Subject: FCC Class II Permission change for FCC ID: 2AIZN-X6855

This is to request a Class II permission change to our Mobile Phone; Model: X6855, FCC ID: 2AIZN-X6855, the device is identical to the previously certified except for the changes as below for details:

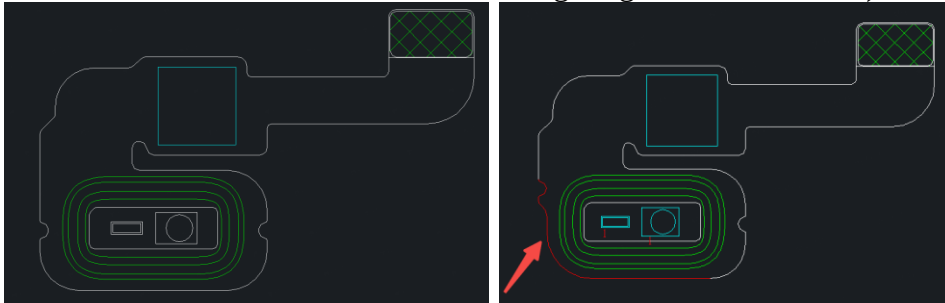
1. WPT Antenna: Enlarged appearance (The total length of the FPC dimensions is increased by 7.55mm, the width is increased by 10mm, and the charging power remains unchanged);
2. MINI LED FPC, Reduced appearance (Cut the red line pointed by the arrow 0.6mm inwards, which will not affect the lighting function or color.)
